11th January 2024 Planning Committee Addendum

Item 6.1 21/02431/FUL – Development Site Former Site Of 17 - 21 Dingwall Road, Croydon, CR0 2NA

Item 6.2 23/02918/FUL - 29-31 Hollymeoak Road CR5 3QA

PROPOSED SECTION C - C

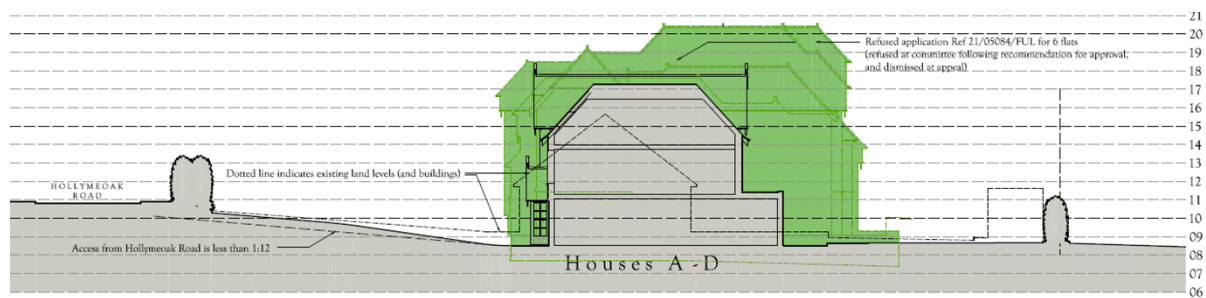
In para 7.11, the section drawing shown within the agenda report actually compares a previously refused flatted scheme (22/01498/FUL) rather than the dismissed appeal development (21/05084/FUL). The section and comparison for the current and dismissed scheme is shown below – proposed section C-C:

PROPOSED SECTION B - B

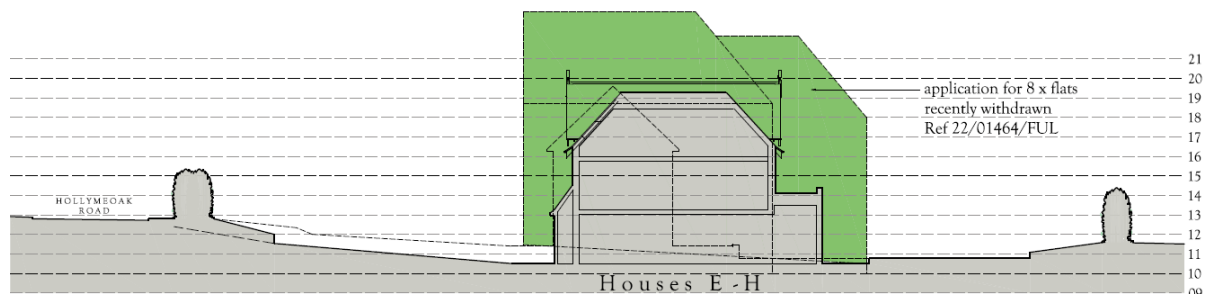
Section B-B below shows the proposed development on the plot of no.31 Hollymeaok Road and compares it with an application for 8 flats on the site (22/01464/FUL) which was ‘finally disposed of’ by the Local Planning Authority.
